RE: Rapid Impact Compaction, Micropile & Foundation - Scope of Work for Environmental Considerations
109 Marbledale Road
Tuckahoe, New York 10707
BCP Site No. C360143

The New York State Department of Environmental Conservation (Department) has reviewed the subject document dated May 8, 2017. The subject version was received by email at 4:17PM on May 8 and watermarked "Final - Approved". The scope was revised based upon Department and HDR comments.

With the clarifications below, the scope is approved as far as the Department is concerned. It is my understanding that the Village must also approve the scope of work per the planning board resolution.

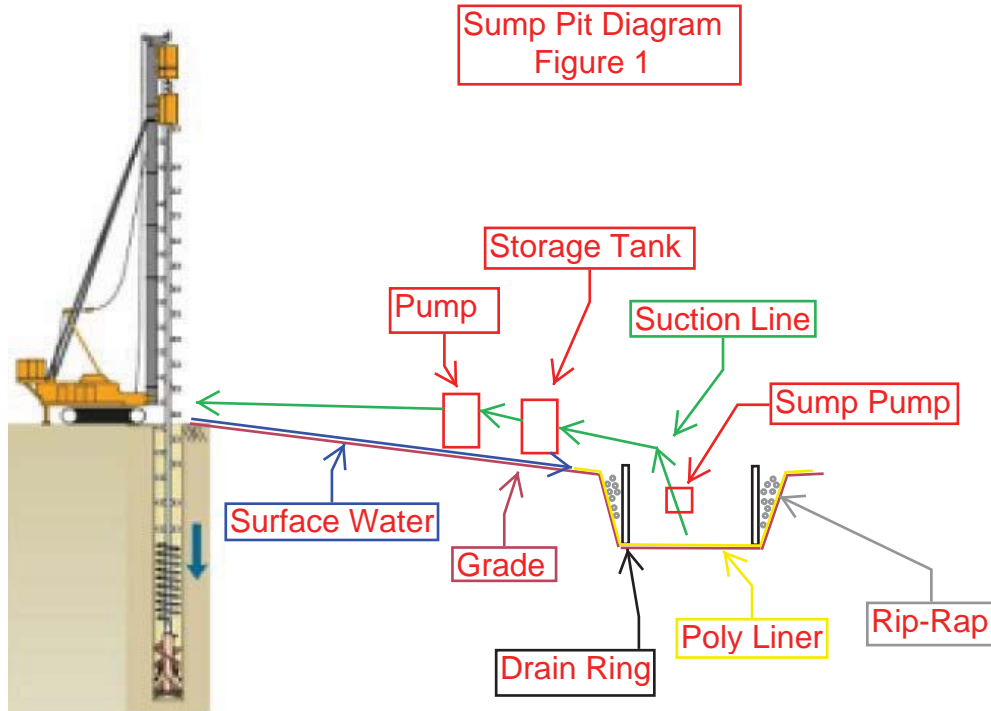
- The channel from the boring location to the collection pit for the mud rotary drilling will be lined with plastic as per our discussions. This was not specifically reflected in the text or Figure 1.
- The text and figure 3 in regard to the vapor point design are not in complete agreement. The text more accurately reflects the discussion in terms of screen length and should be followed.
- It is the Department's understanding that the compaction will begin in the identified area in the northwest corner of the site following installation and sampling of vapor points.
